Project	IEEE 802.16 Broadband Wireless Access Working Group < http://ieee802.org/16 >	
Title	An Efficient AMC Zone Allocation within H-ARQ for MIMO OFDMA	
Date Submitted	2004-11-4	
Source(s)	Wonil Roh, JeongTae Oh, Chan-Byoung Chae, Kyunbyoung Ko, Hongsil Jeong, Sung-Ryul Yun, Seungjoo Maeng, Jaeho Jeon, Jaeyoul Kim, Soonyoung Yoon	wonil.roh@samsung.com Voice: +82-31-279-3868
	Samsung Electronics Co., Ltd.	
	Young-Ho Jung, Seung Hoon Nam , Jaehak Chung, Yungsoo Kim, Sung-Jin Kim, Hojin Kim	
	Samsung Advanced Institute of Technology	
Re:		
Abstract	An Efficient AMC Zone Allocation within H-ARQ for MIMO OFDMA	
Purpose	Adoption of proposed changes into P802.16e Crossed-out indicates deleted text , <u>underlined blue indicates new text change to the Standard</u>	
Notice	This document has been prepared to assist IEEE 802.16. It is offered as a basis for discussion and is not binding on the contributing individual(s) or organization(s). The material in this document is subject to change in form and content after further study. The contributor(s) reserve(s) the right to add, amend or withdraw material contained herein.

An Efficient AMC Zone Allocation within H-ARQ for MIMO OFDMA

[Figure aaa An Example of Time Zone Allocation for AMC Region in DL H-ARQ MAP \(Method 1\)](#)

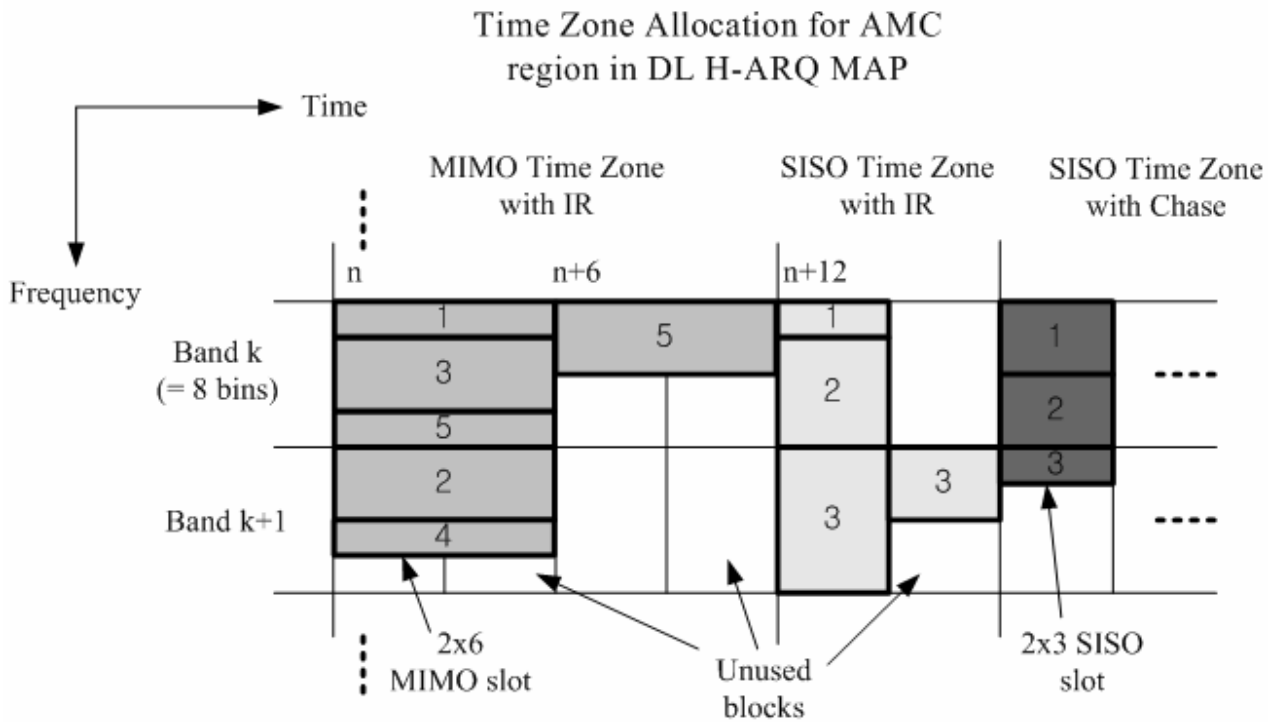
Figure aaa and Figure bbb represent two methods of MIMO zone allocation within AMC band region, time zone allocation in Figure aaa and frequency band allocation in Figure bbb. Each scheme has its own pros and cons. The time zone allocation method has better channel estimation performance due to continuous pilot subcarriers along the entire frequency domain, improving decoder performance and frequency scanning for better choice of an AMC band. On the other hand, frequency band allocation method reduces overhead which otherwise is inevitable at symbol boundaries of different zones. Furthermore, in terms of granularity this method is better because a MIMO or SISO zone can be allocated to one or more bands of the total available bands (12 for the case of 1K FFT and 8 bins per band configuration), whereas 3 (for SISO) and 6 (for MIMO) symbols are the basic unit to be allocated within the available DL sub-frame (24 symbols for the case of 1K FFT with 2:1 DL:UL ratio).

Figure aaa and Figure bbb represent two methods of MIMO zone allocation within AMC band region, time zone allocation in Figure aaa and frequency band allocation in Figure bbb, where 1K FFT size, 12 AMC bands and 2x3 basic AMC type are assumed for illustration purpose.

[Add a new section 6.3.2.3.43.6.9 as follows]

The switch between these two methods shall be indicated by H-ARQ Compact DL-MAP IE for MIMO Zone Indication.
